WORTHINGTON, SKILLING, HELLE & JACKSON — Civil & Structural Engineers

PROJECT: THE WORLD TRADE CENTER | TITLE: LOUVER SUPPORTS - DETAILS F & G | DATE: 12-20-67

Detail G

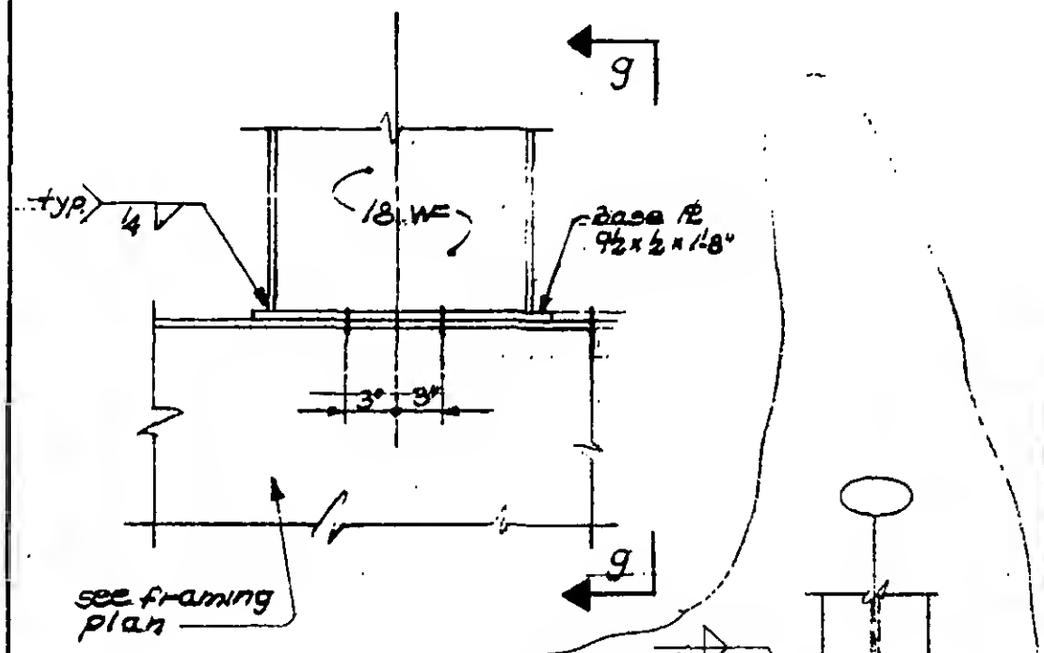
8-29-68

Use detail only where beams differ in size. If beams are same size use detail shown at left.
